V3_Drainage Report - Final_comment.pdf Markup Summary

FINAL DRAINAGE REPORT
FOR

Chick-fil-A Powers & Palmer Park

PCD File No. PPR2521

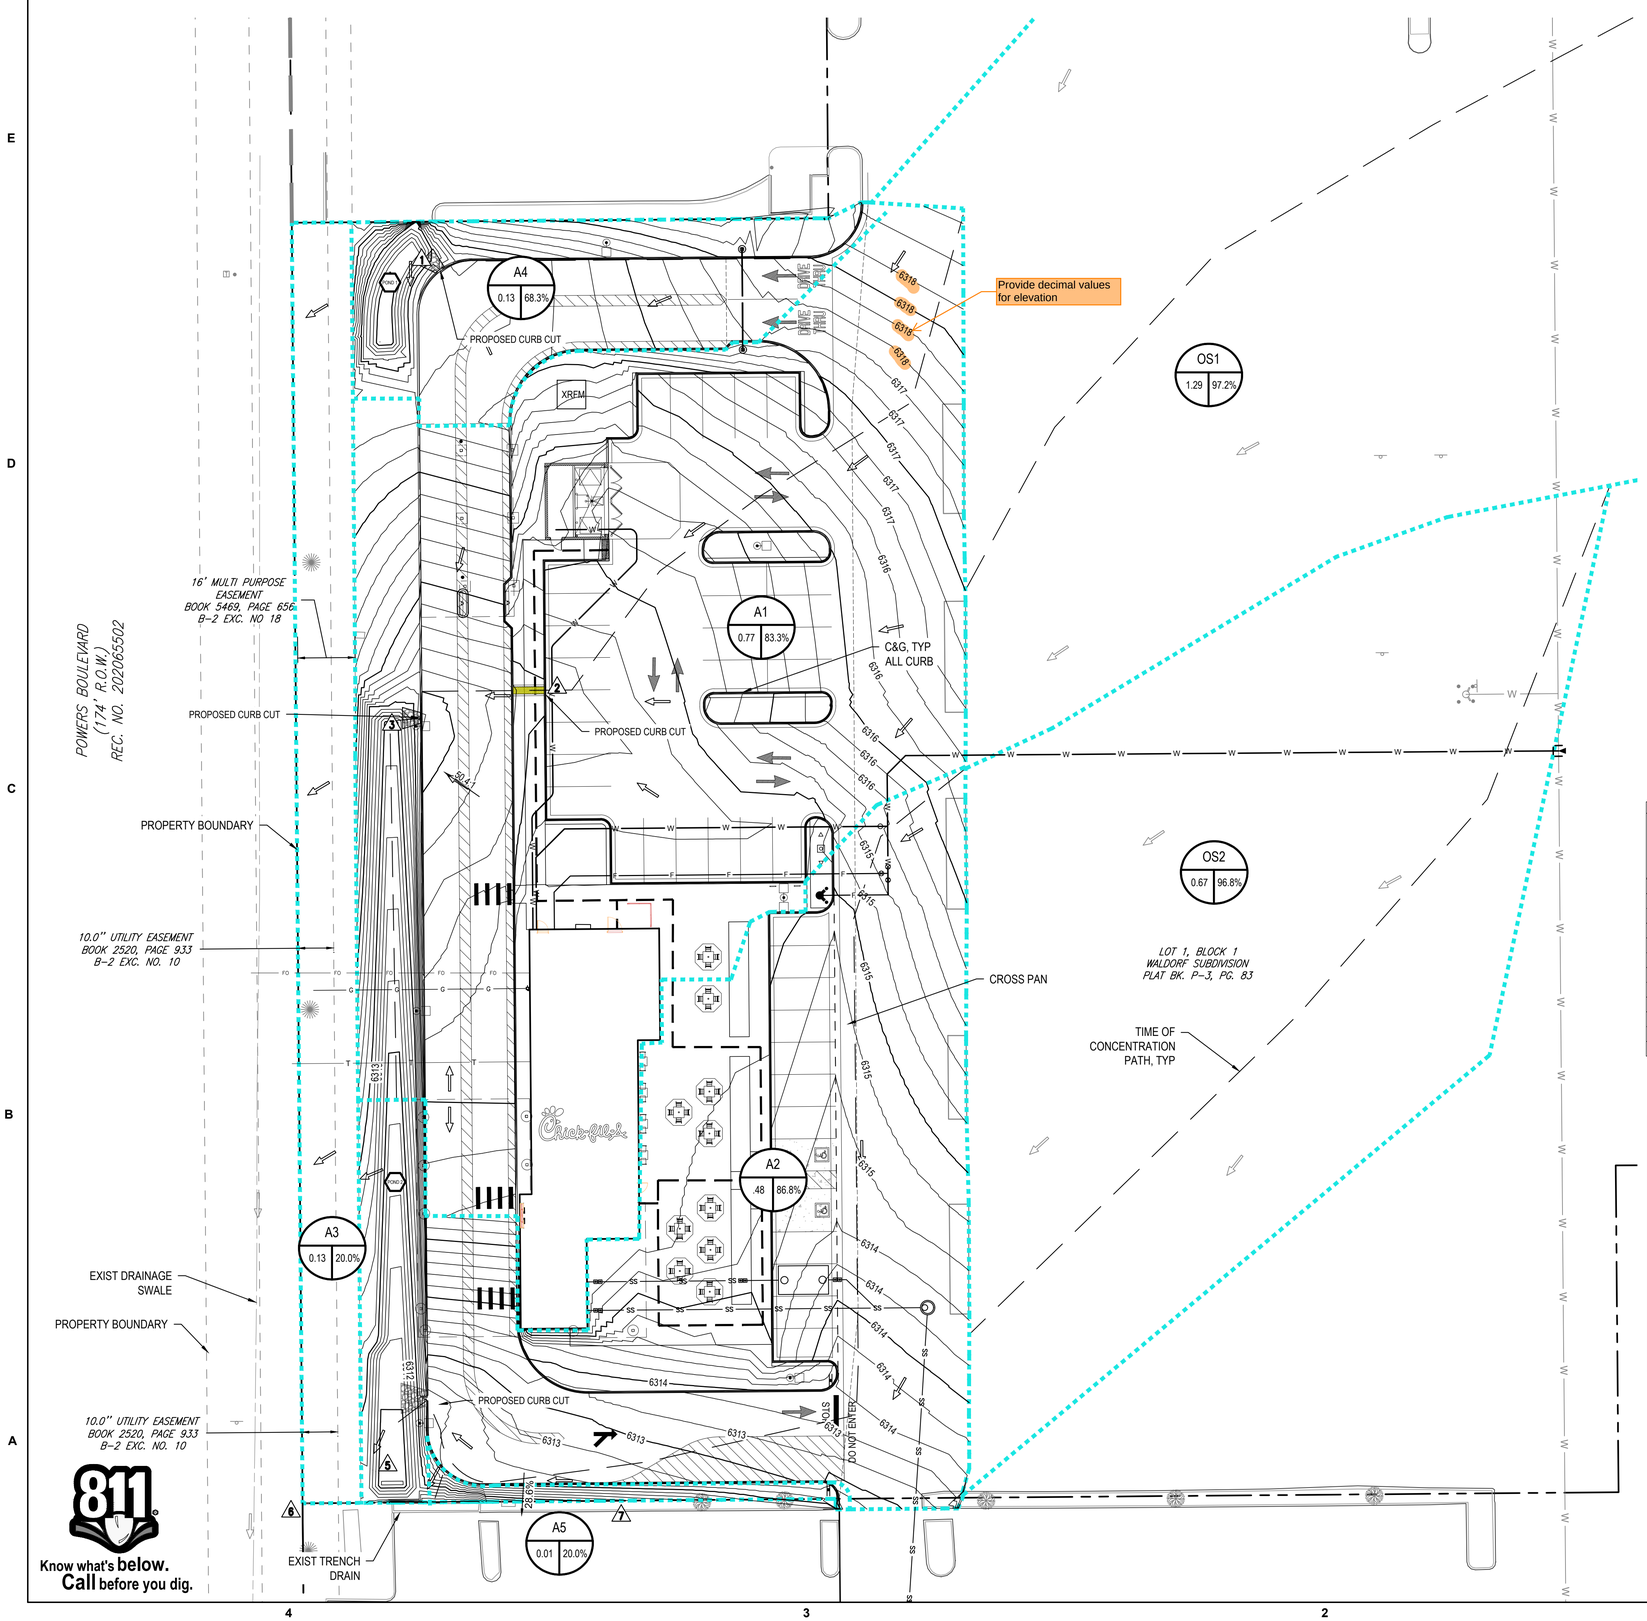
Include a cost estimate for each SF basin with line items for all components (ex: riprap, road base, forebay, trickle channel, outlet structure, outlet pipe, spillway, etc). Input the total value into the FAE form under "Permanent Pond/BMP (provide engineer's estimate)" in Section 1. The total should not include grading, which is a separate line item in Section 1: "Earthwork." The cost estimate should include labor costs (as a separate line item or added into the cost of each component).

Channel Report

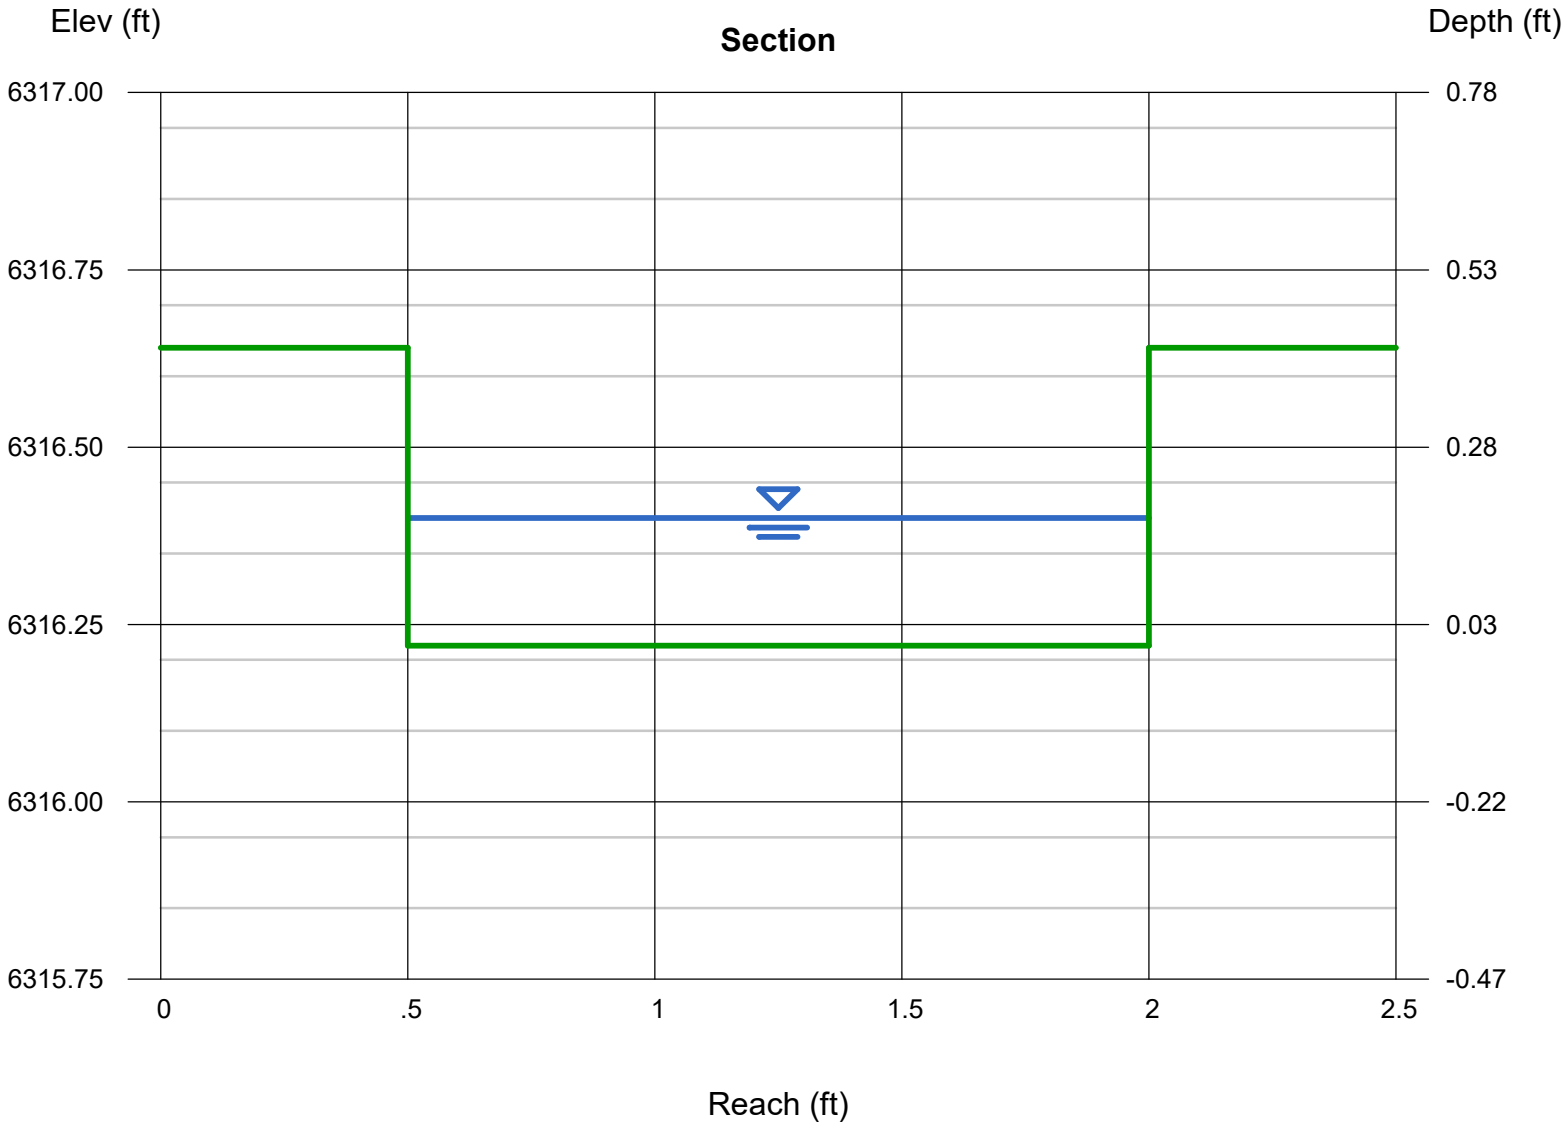
Highlighted
